Engineering Services Department

Addendum No. 1

PROJECT: ES-01-17 SOUTHLAND BOULEVARD ROADWAY
IMPROVEMENTS - PHASE I

SUMMARY OF QUANTITIES

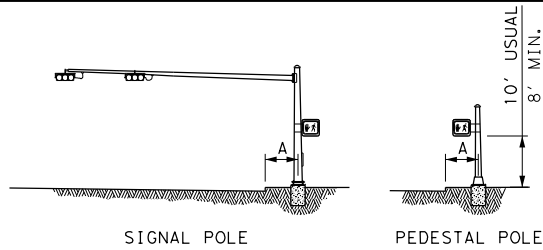
2. Q: The Plans are missing page 5, General Notes.
A: The General Notes have been added.
3. Q: The Quantities in the Basis of Estimate on plan sheet no. 6 are not even close to correct.
A: The Quantities in the Basis of Estimate have been updated on plan sheet no. 6 and have also been updated on the Bid Form.

SOUTHLAND BOULEVARD
SIGNAL MODIFICATION
AT SAM'S/WAL-MART DRIVEWAY

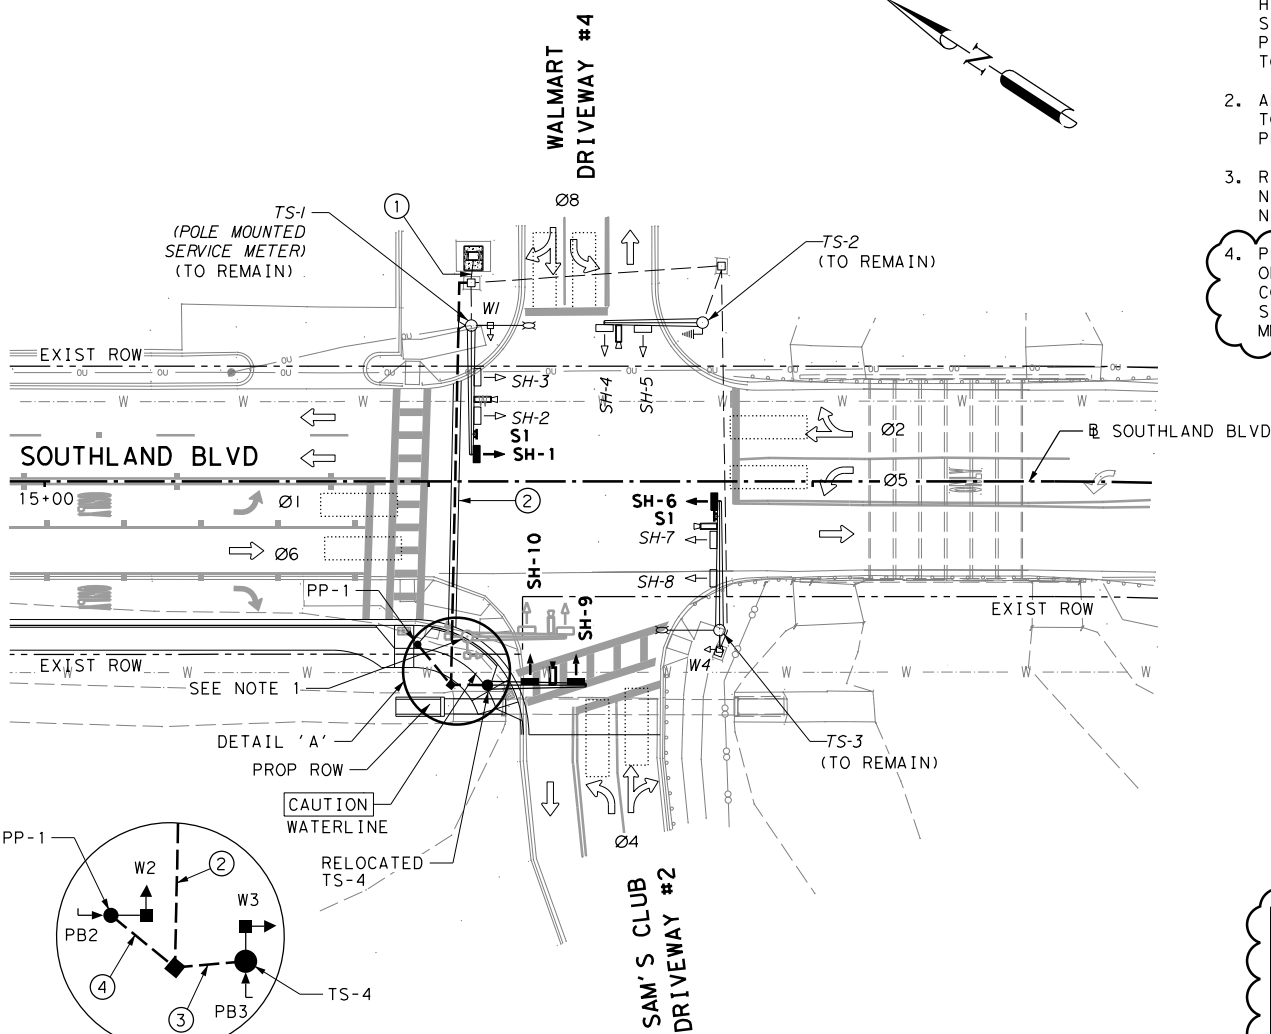
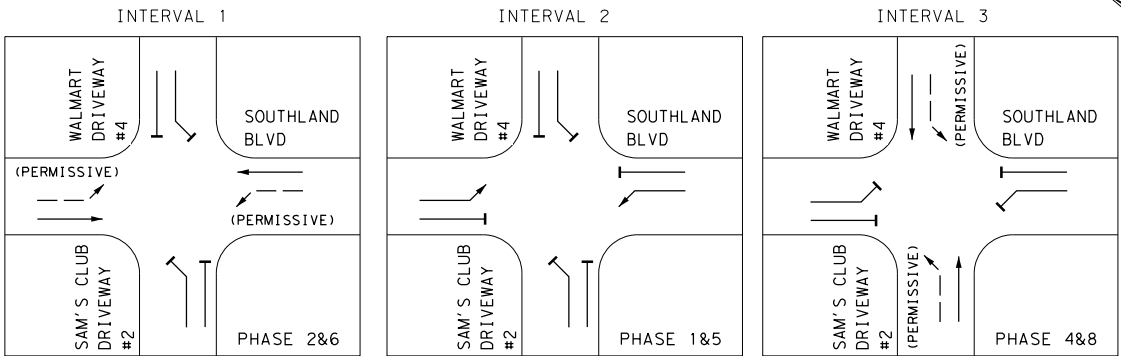
11. Q: Regarding Bid items 43 & 44, please clarify the city's intent with the signal head quantities.
A: The signal head quantities have been removed from the Bid Form. See attached Revised Plan Sheet 48.

REV. NO.	DATE	DESCRIPTION	BY
1	1/11/2017	REPLACE TRAFFIC CONTROLLER	JO
